BOROUGH OF OCEANPORT

AGENDA • OCTOBER 18, 2021

PB2020-29.1 PHASE II Warehouse Parcel - Oport Partners LLC

RE: Preliminary and Final Major Site Plan – Engineering Review #1
Applicant: Denholtz Partners, LLC: Application No. PB2020-29.1
Phase II: Block 110.13, Lot 1
Fort Monmouth, Borough of Oceanport, Monmouth County, NJ

Figure 1- Warehouse District

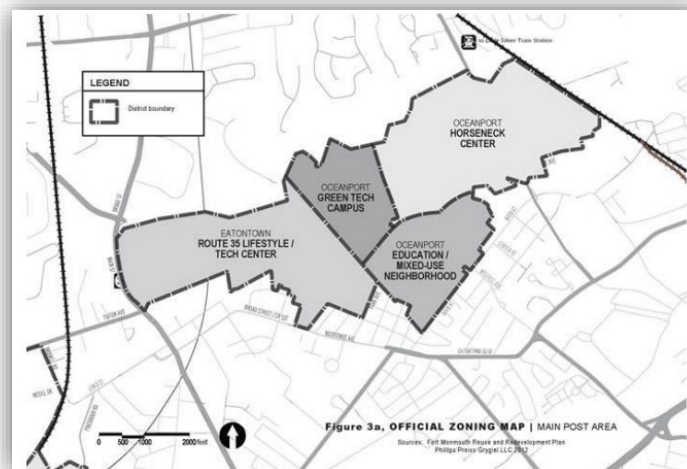
- 2.1 The subject property is located within the Warehouse District, which is an overlay zone within the Oceanport Education/Mixed Use Neighborhood Zone. Amendment #15 of the Fort Monmouth Reuse and Redevelopment Plan adopted June 2020 created this alternate zoning as follows:

“This amendment does not purport to delete any provisions of the Reuse Plan but rather supplements the Plan by proposing alternative development scenarios for the parcels in the Fort area as shown as shown on Appendix B. Under N.J.A.C. 19:31C-3.19(a)(1), principal land uses permitted in the Reuse Plan are specifically permitted under the

Land Use Rules. Thus, this amendment is incorporated into the Land Use Rules for the Reuse Area in a manner similar to an “overlay zone,” whereby an alternative set of requirements are superimposed on the area allowing for alternative land use scenarios to be realized. With regard to the alternative land use scenario, the overlay zoning provides alternative opportunities for development that do not apply unless the land is developed in accordance with the purposes for which the overlay zoning is adopted.”
